Product Change Notice - Announcement

PCN no.: P25-2015-001
Date: 2015-04-27
PCN Type: Information
Subject: EGO[®] Radiant Heating Elements - omission of P1 tab
Reference: Product Management - Tilo Fucik

4. Identification of change

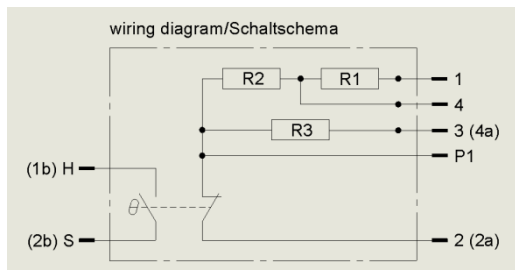
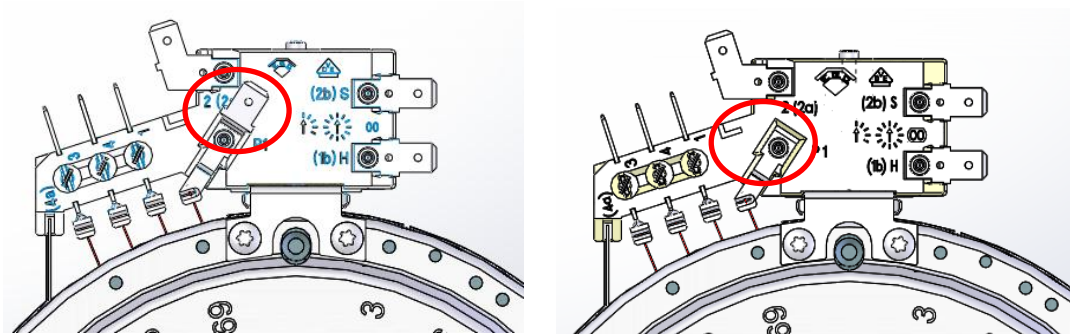
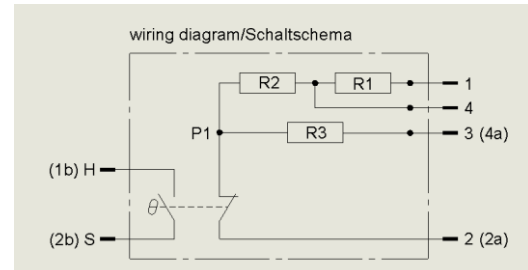
Continuous improvement of E.G.O.'s products and market observation has given the proof that the P1 tab on the below-mentioned EGO[®] types is not needed. Actually, the P1 terminal could even lead to failures or miswiring during the assembly of the heater in the hob.

The function of the limiter remains unchanged.

This change is made in order to help to increase the product quality within the hob production.

For further explanation please see the pictures below.

old version

new version
